**CALHOUN-GILMER CAREER CENTER  
CALHOUN COUNTY, WEST VIRGINIA  
CALHOUN-GILMER CAREER CENTER RESTROOM RENOVATIONS**

**ADDENDUM #2**

**AUGUST 13, 2021**

**THRASHER PROJECT #060-10226**

SHEET No.  
**P2.02**

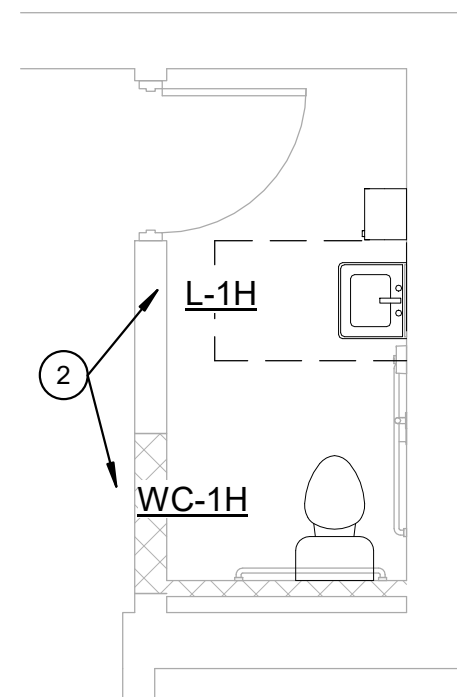
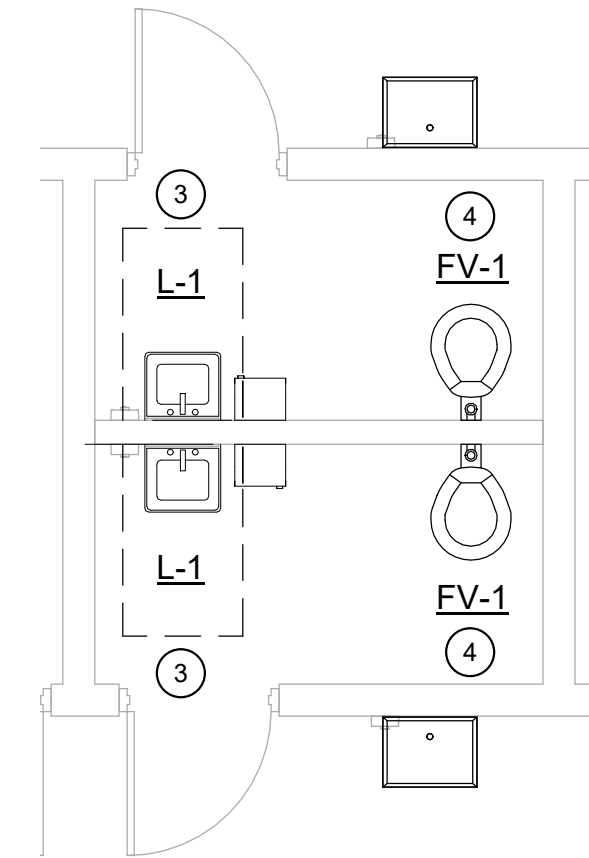
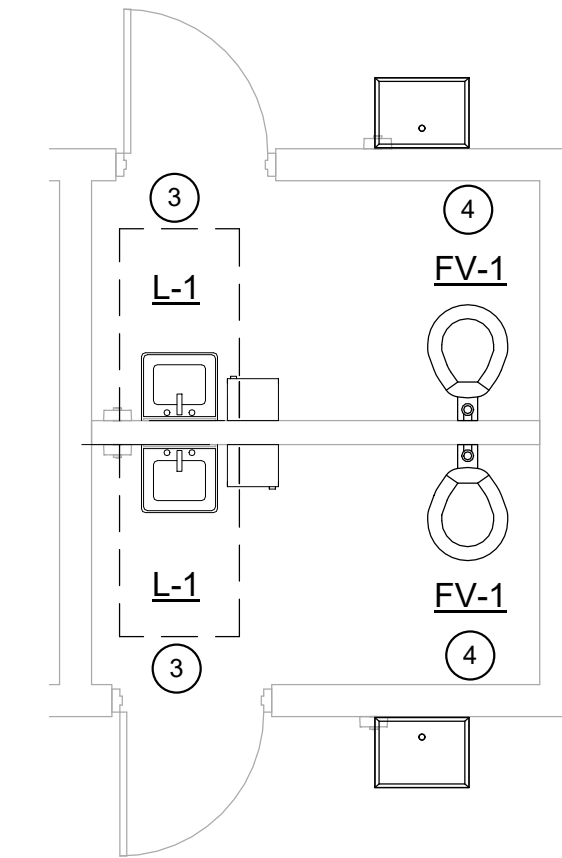
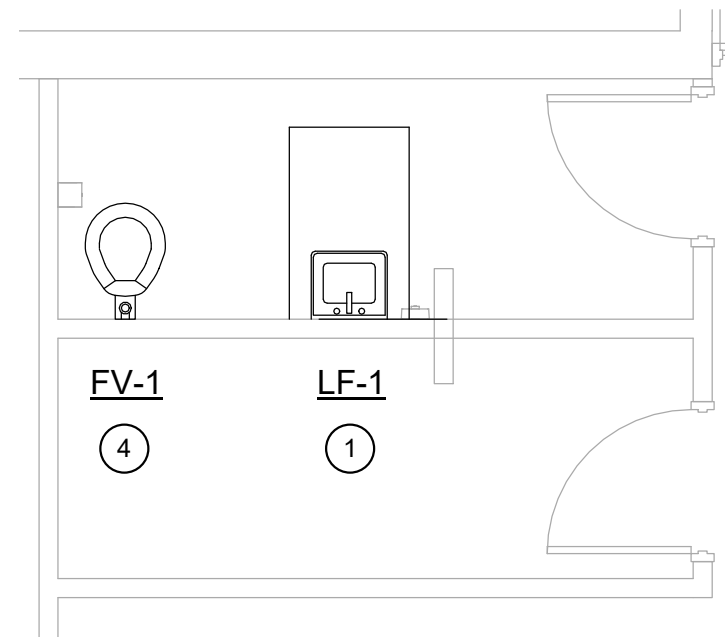
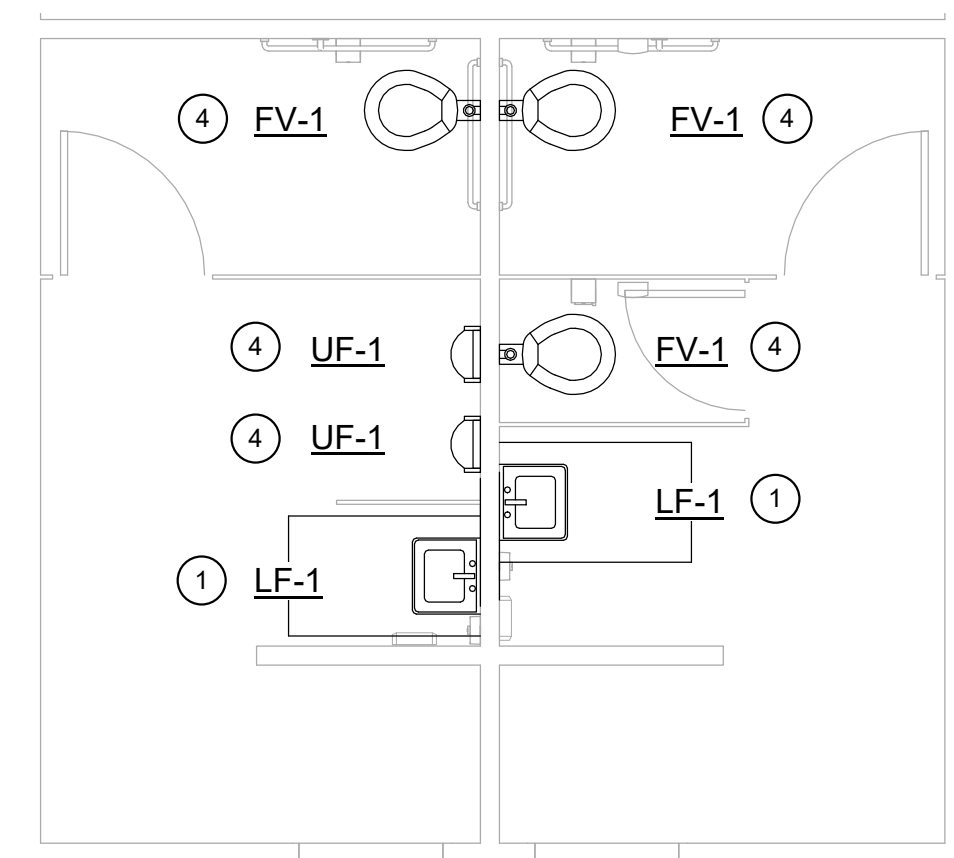
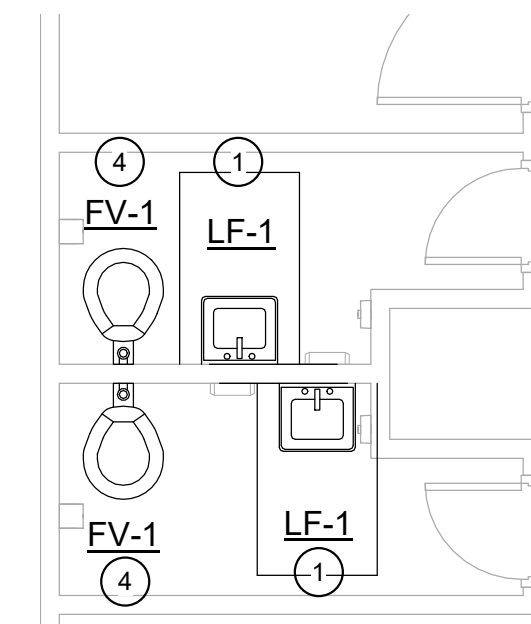
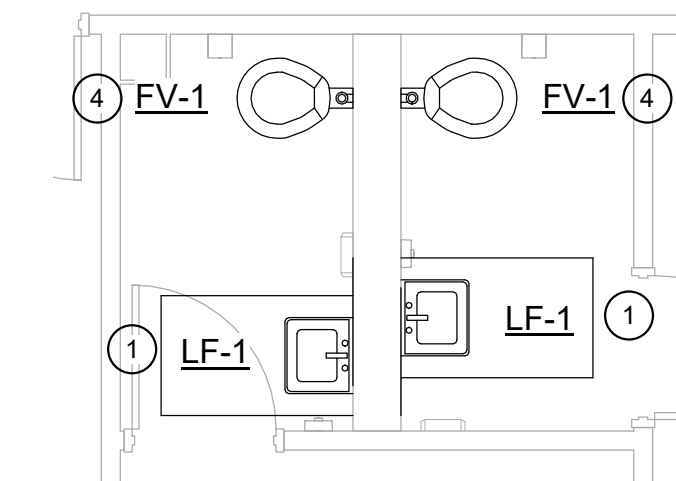
2. Drawing P2.01 shows fixtures being removed – are new fixtures being installed?  
There is a fixture schedule but no drawing showing what goes where.

7. Rooms 123, 124, 133 and 134 – Urinal gets removed, it appears a sink gets installed where the urinal was located (plumbing drawings don't show anything being installed back) If a sink gets installed there does hot water need to be run to the sink, if so do we pick it up from the sink outside the restroom? Can piping be surface mount?

9. Sheet A1.02 New Construction Note 4 - New Sink. Patch and repair CMU walls where urinals have been removed. The Architectural Drawing identifies the new sinks, the summary identifies new plumbing fixtures, could the Enlarged Plumbing Plan P2.02 be provided?

16. Need to know if existing fixtures to remain need to have new flush valves installed? (Water Closets, Urinals, Lavs)

17. Need to know which New Lav's are to be L-1 or L-1H ADA. Rooms 46-47, Rooms 123-124 and Rooms 133-134.

18. Rooms 141, 107 & 108, 151 & 152 are on the A1.01 but are not on any other drawings. Not sure if I need to exclude these rooms.

See Drawing P2.02 attached to this addendum.

See Drawing P2.02 attached to this addendum.

See Drawing P2.02 attached to this addendum.

See Drawing P2.02 attached to this addendum.

See Drawing P2.02 attached to this addendum.

See Drawing P2.02 attached to this addendum.

21. Restroom 141 is not identified on Sheet A1.02 Restroom 141 is identified on Sheet P2.01 with Plumbing Demolition Plan Key Notes Tagged 1. Restroom 141 is identified on Sheet E2.01 with no Lighting & Systems Key Notes and the restrooms

See Drawing P2.02 attached to this addendum.

19. Restrooms 107 & 108 is not identified on Sheet A1.02, Restrooms 107 & 108 is identified on Sheet P2.01 with Plumbing Demolition Plan Key Notes Tagged 1. Restrooms 107 & 108 is identified on Sheet E2.01 with no Lighting & Systems Key Notes and the restrooms are identified again on Sheet ED2.01 with no Lighting & Systems Demolition Key Notes.

- A. Is the only scope of work in restrooms 107 & 108 for Alternate # 2 only?
- B. Requesting clarification of base bid work and alternate work.

See Drawing P2.02 attached to this addendum.
